# INDIANA DEPARTMENT OF TRANSPORTATION

## FINAL DRAFT MINUTES

### March 20, 2026, Standards Committee Meeting

RE: Minutes from the March 20, 2026, Standards Committee Meeting

INDIANA DEPARTMENT OF TRANSPORTATION	
RETROFIT TRANSVERSE JOINT DETAILS	
SEPTEMBER 2026	
STANDARD DRAWING NO. E 506-CCPP-04	
DESIGN STANDARDS ENGINEER	DATE
CHIEF ENGINEER	DATE

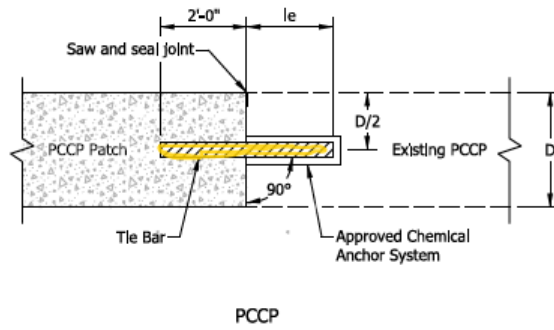
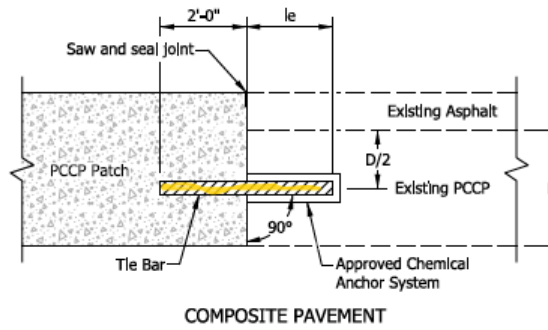
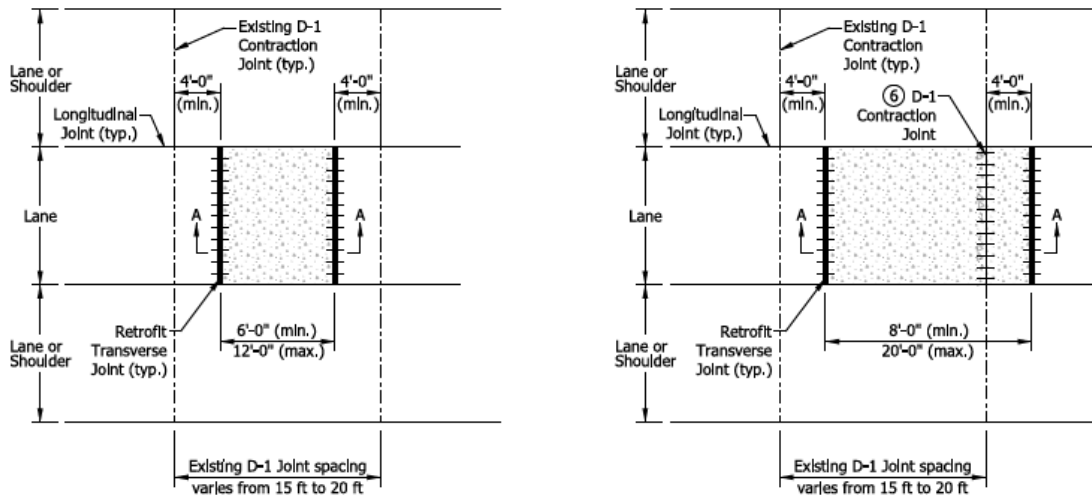
In reference to drawing 506-CCPP-04, Mr. Koch stated that he is uncertain as to our expectations, usually deformed bars are depicted with hatching. Are we intending smooth or deformed retrofit transverse joint tie bars? Observing the installation of retrofit bars over the years, it is a struggle for a crew to consistently

glue the bars into the correct plane. I tend to believe/assume most retrofit joints will be locked due to out of plane bars. Mr. Dave agreed and stated that the dowels bars shall be deformed, as stated above.

Mr. Cosenza added that the proposed change to an epoxy for a saw cut into the existing slab, not at an existing joint, is not as clearcut as it first appears. The chemical anchor system specification and requirements are specifically for epoxies bonded to steel and has a pull out strength requirement. I don't believe referencing the chemical anchor system to fill in the saw cut will work without additional changes to the specification. I do have an epoxy for random longitudinal crack remediation for 503.06 and 901.06, which looks to be the closest match. I would propose some changes if we do go the epoxy route. I do still believe the hot pour joint sealant would work for both joint and slab saw overcuts.

In reference to drawing 506-CCPP-04 (05 & 06), Mr. Koch suggested that, in order to avoid confusion as deformed bar is preferred at the construction joint, please consider amending the thickness of the depicted tie bar in a manner that differs from d-1 / dowel bars, similar to 503-CCPJ-02.

- Updated hatch of tie bars to align with the 503-CCPJ series.
- Removed hatch of dowel bars to remain consistent with the 503-CCPJ series.
- Added a new saw-cut detail to Sheet -03 to address the potential for diagonal cracking in the lane when a longitudinal saw cut is made at a narrow shoulder. Based on discussions with Nick Cosenza, the cracking risk appears to stem from pouring the lane and shoulder monolithically (16-ft slab). Added new Note 6.
- Revised Sheet -03, Note 1 to allow epoxy in lieu of hot pour, as approved.
- Revised the table on Sheet -04 to specify a minimum 1'-0" embedment (le) for all tie bar sizes.
